INTRODUCTION

This chapter provides responses to the substantive comments on the Draft EIS (DEIS) made either verbally at the Public Hearings on the DEIS held on March 9, 2022 and April 13, 2022, or provided to the City of Yonkers Planning Board (the “Planning Board”), as Lead Agency, from February 2, 2022 through April 27, 2022. A list of commenters is provided below. The full transcripts of the Public Hearings and the correspondence from which the comments are drawn are included in **Appendix A**. Comments having a similar subject or raising similar technical points are grouped together. In some cases, for ease of reading, an introduction to a group of similar comments is provided (see e.g., Comment Gen-5).

AMS Yonkers Downtown Development

Construction Truck Turning Diagram - North Broadway
Phase 2 - 40-foot Straight Truck Entering Site

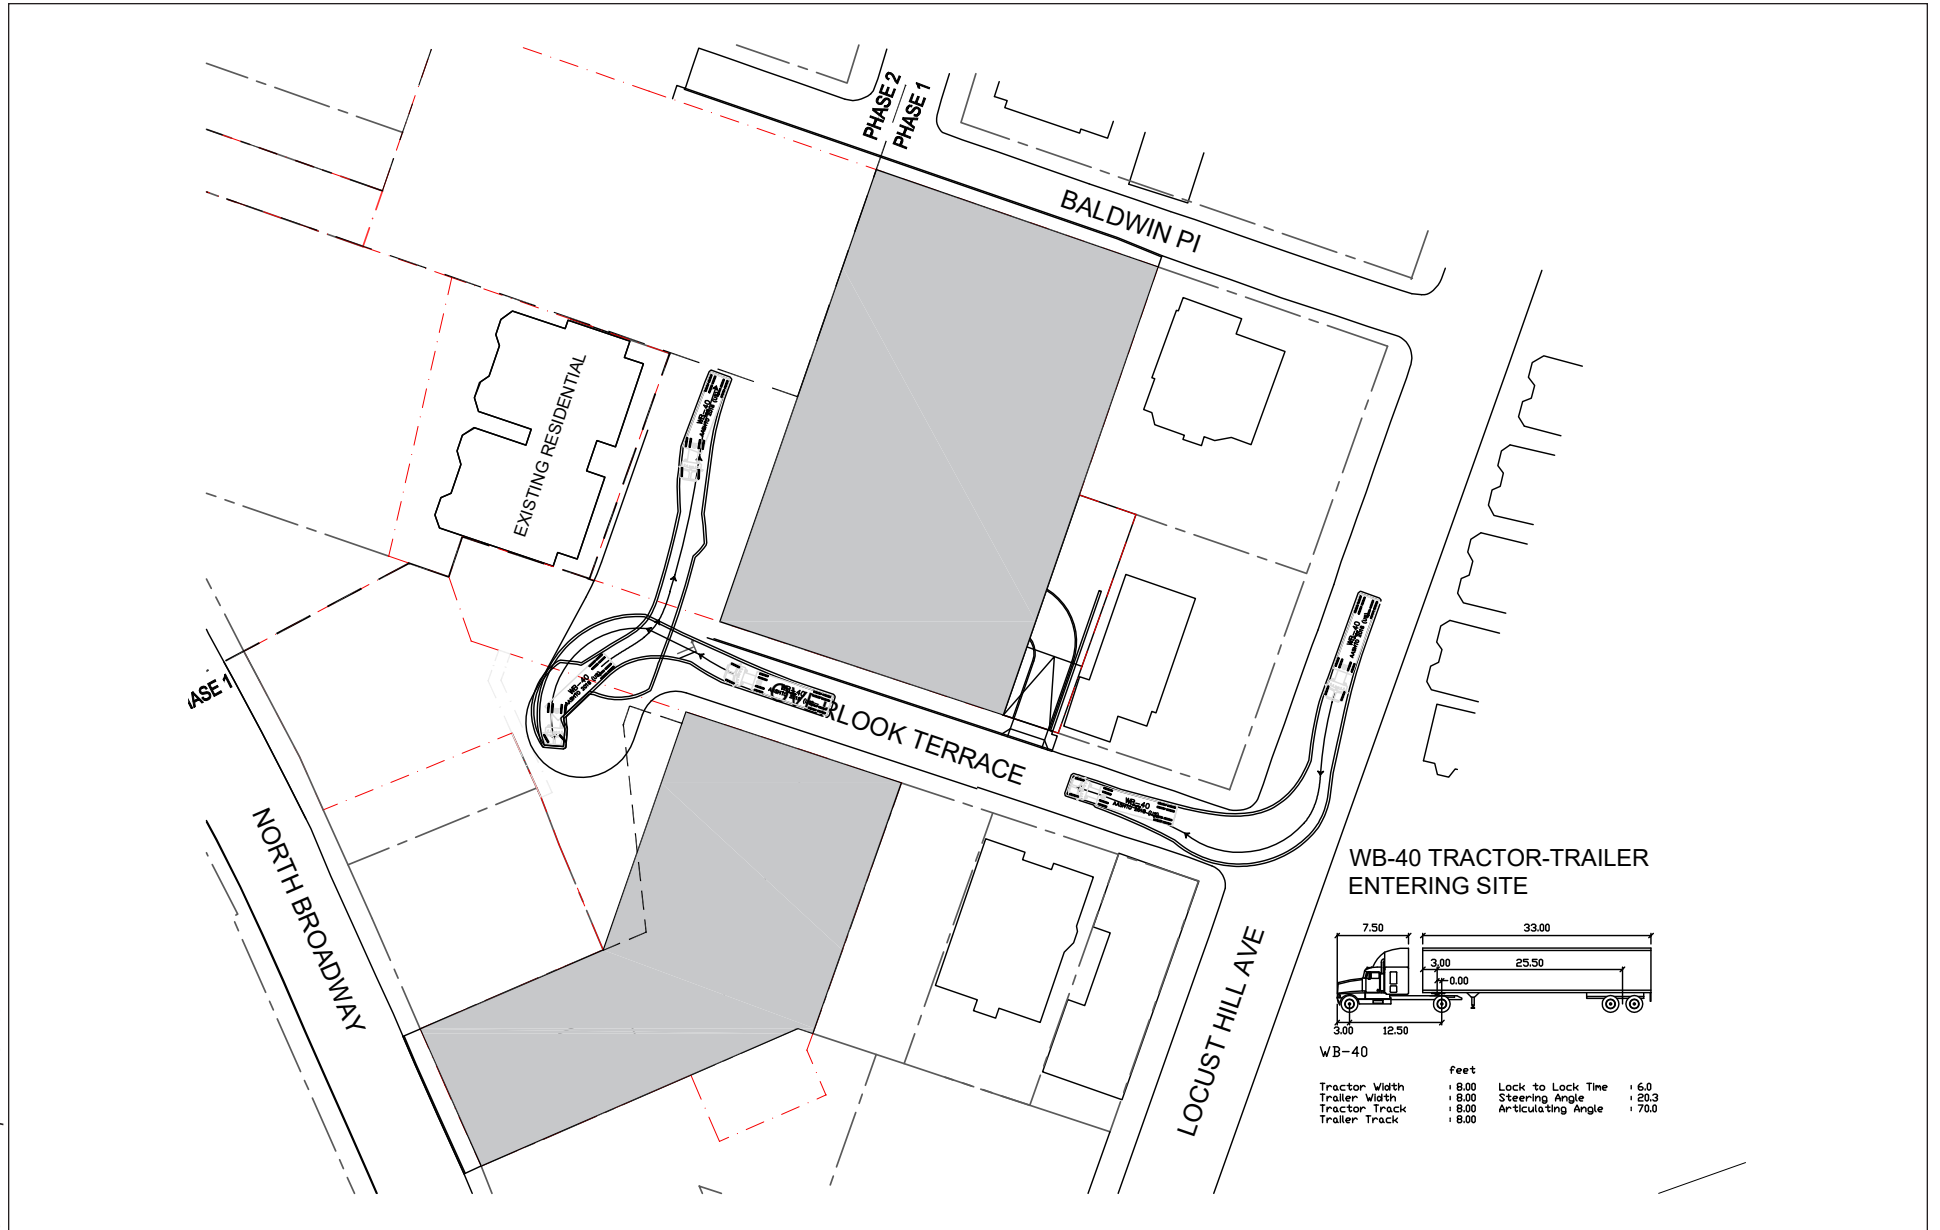
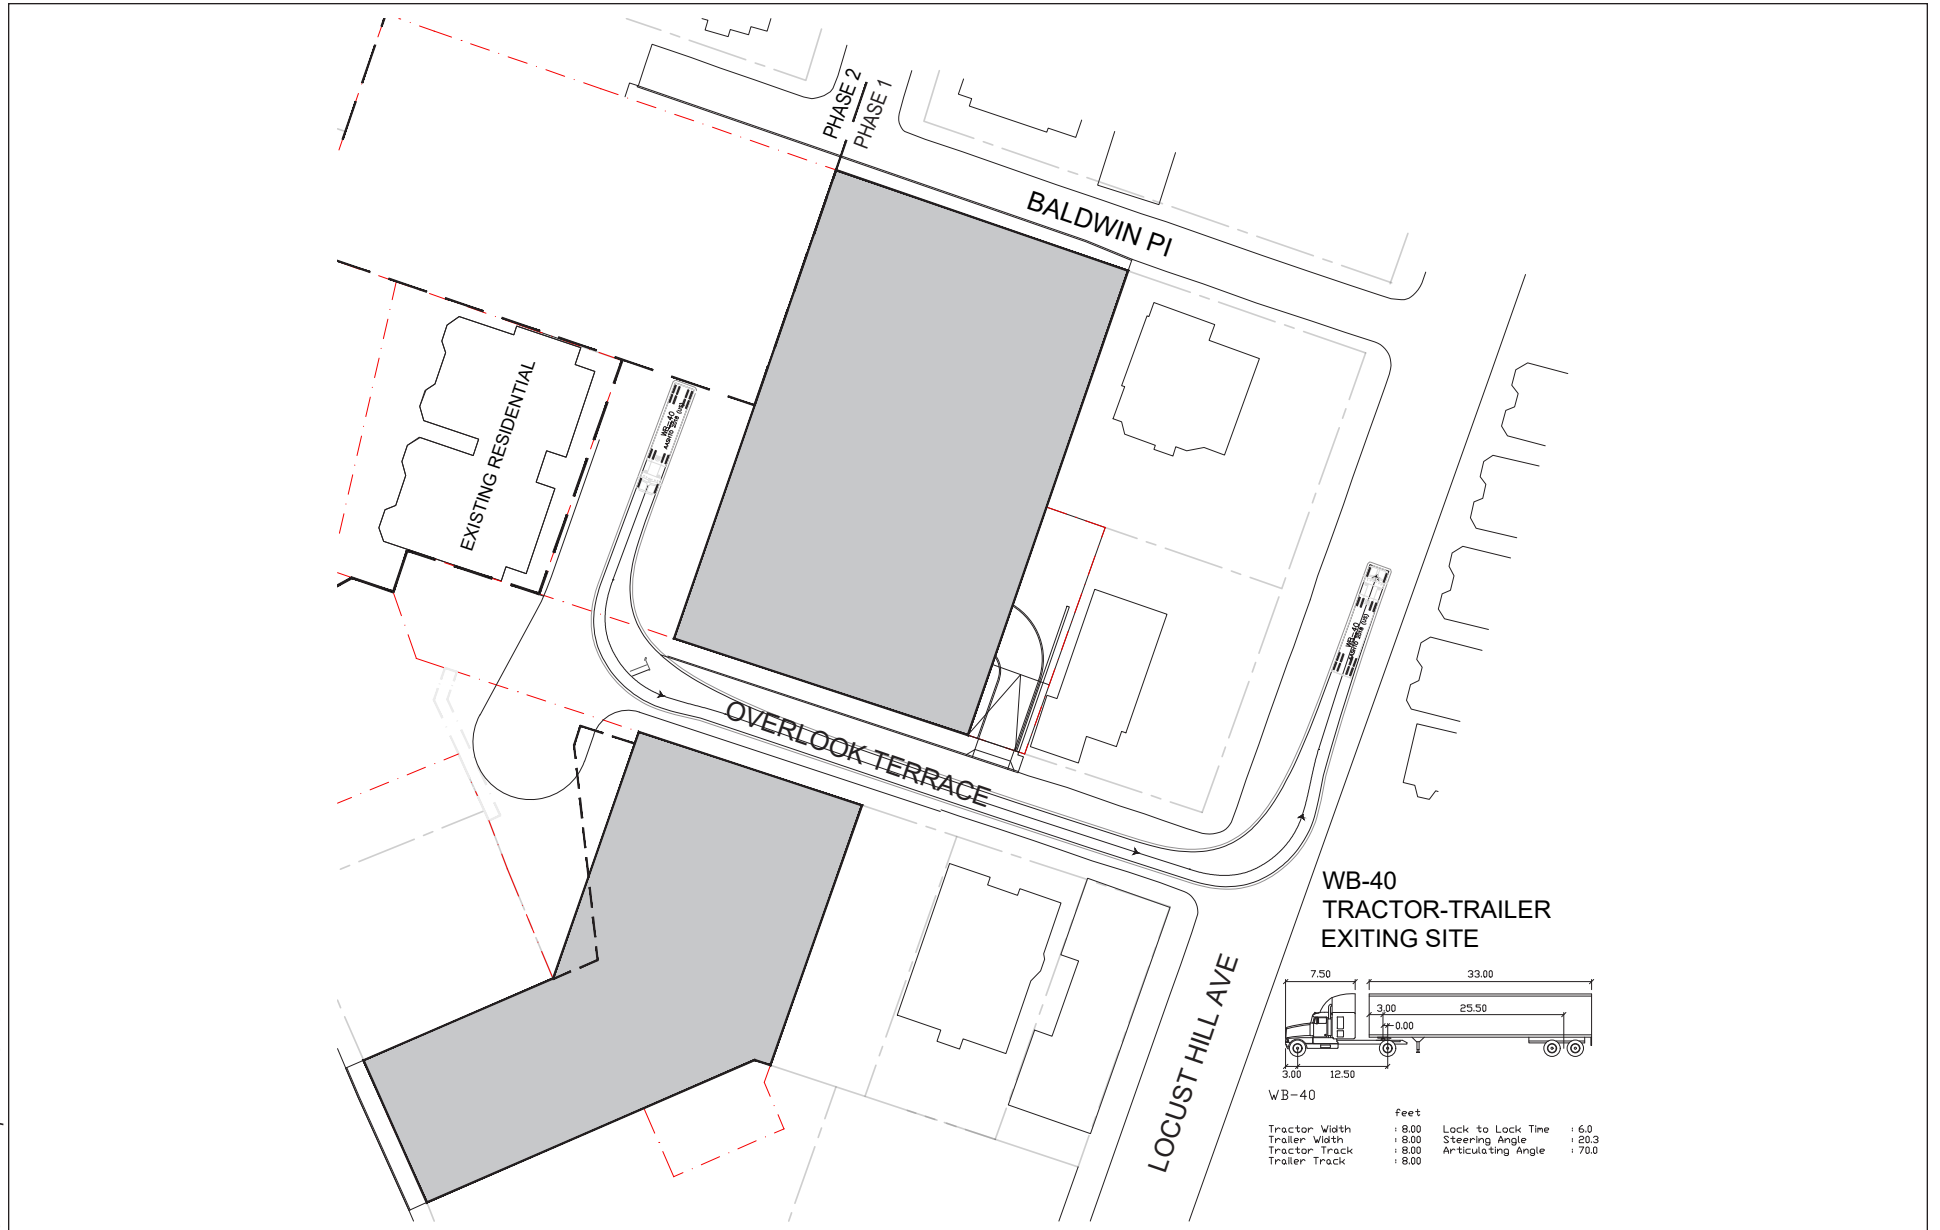
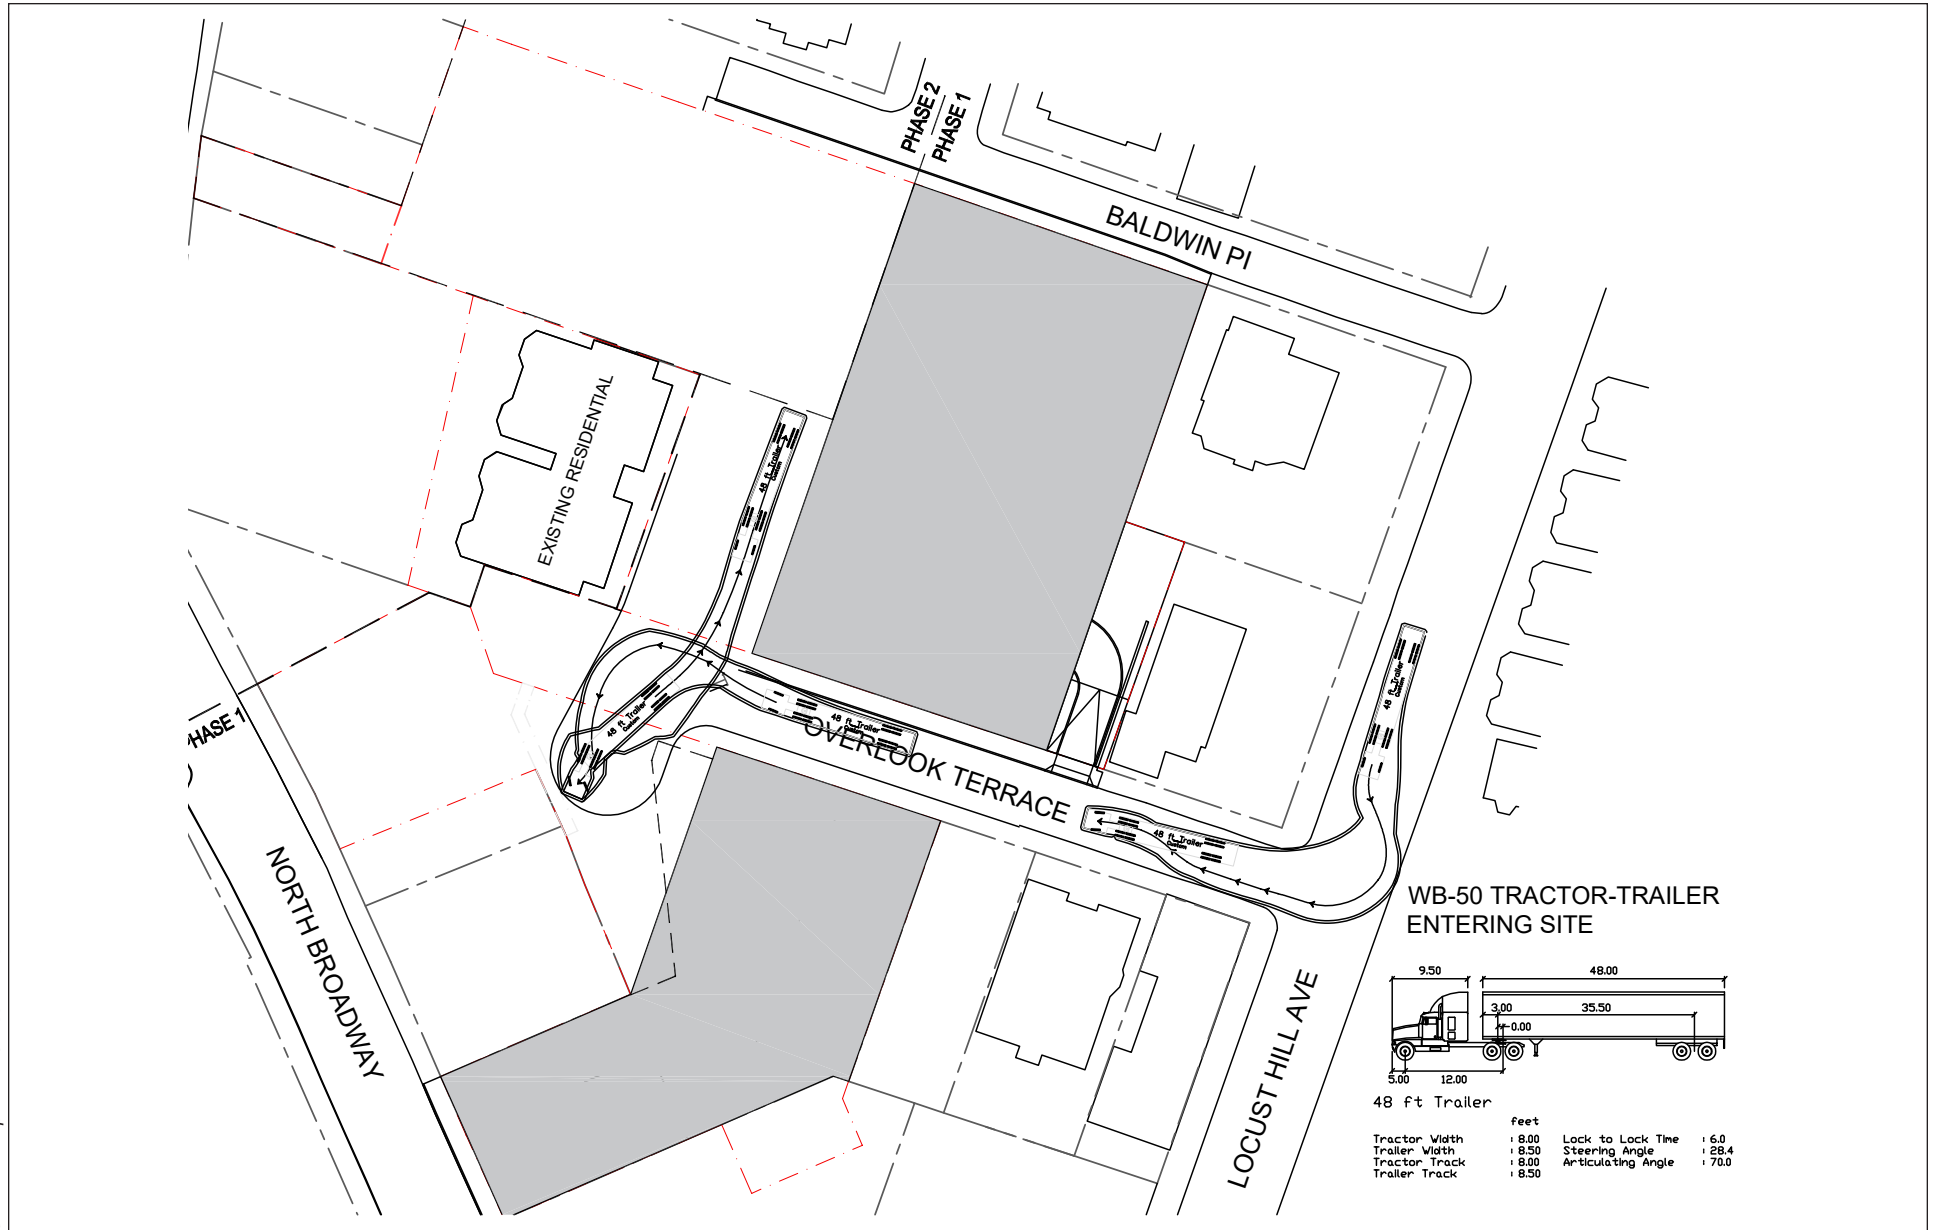
Figure 15-2 thru 15-12 Construction phasing diagrams – Understanding that these diagrams are schematic and draft they illustrate the improbability of statements made in the narrative that construction operations would take place on the sites. For example, materials delivery is almost inconceivable to be able to take place wholly on the Teutonia site without use of Buena Vista Ave for delivery with the then almost assured closures of the street to traffic. Therefore, alternate routes for traffic and drop off for area businesses and institutions at all of the sites need to be thought out during the EIS process. (Nersinger_031)

Same comment for the North Broadway Site and the projected figure of 2,400 truck trips for earthwork and excavation. Specific to this site, how will construction vehicles enter and exit the site? North Broadway is a one-way street near the site, and Locust Hill Ave, is narrow with a steep rise in grade from Palisade Ave. (Nersinger_031)

As described in Chapter 2, “Environmental Analysis,” of this FEIS, revised Construction Site Logistics Diagrams (included as **Appendix H-2**) and construction truck routing figures have been provided. The truck routing figures illustrate, conceptually, where trucks would stage and unload at each Project Site. Also shown, conceptually, is the extent of lane closures in front of the Project Sites. As part of Site Plan review and prior to construction, the revised Construction Site Logistics Diagrams would be finalized and would include the specific measures required to mitigate impacts from loading and unloading, including requirements for traffic control, time constraints and delivery hours of operations.

With respect to the Teutonia Site, the contractor would install a movable barrier parallel to the front lot line, approximately 15 feet from the lot line. Two-way traffic would remain on Buena Vista Avenue. This would be similar to the condition once the Modified Teutonia Project is completed, where, as previously described, only four on-street spaces would remain on the east side of Buena Vista Avenue in order to accommodate movement into the Hudson Street project’s off-Site parking lot and the Modified Teutonia Project garage and to accommodate the widening of the sidewalk between Prospect and Main Streets and the new left turn lane at Buena Vista Avenue and Prospect Street. Surrounding the North Broadway Site, on-street parking would be eliminated during construction on Overlook Terrace, Baldwin Place, and Locust Hill Avenue in the areas just north of Baldwin Place and Overlook Terrace. Similarly, closure of sidewalks at the intersections of Baldwin Place and Overlook Terrace with Locust Hill Avenue may be necessary. These restrictions would be necessary to allow for construction truck movements to and from Locust Hill Avenue to the North Broadway Site. The Applicant would require its Construction Manager, general contractor, and all sub-contractors to limit the size of construction trucks for the North Broadway Project to match the available roadway geometry in this area. Construction truck turning movements were evaluated for the North Broadway site (see FEIS **Figure 3-15**). Truck size would be limited to a 53-foot tractor trailer on Overlook Terrace and Baldwin Place during North Broadway Project Phase 1 and a 50-foot tractor trailer on Overlook Terrace during North Broadway Project Phase 2. Truck size limits would be incorporated in all subcontract and vendor agreements. Deliveries would be closely scheduled and confirmed by the Applicant’s Construction Manager’s site superintendents to avoid getting too many deliveries per day or at the same time. When the superintendents schedule these deliveries, they would remind the trucking companies of the truck size limits.
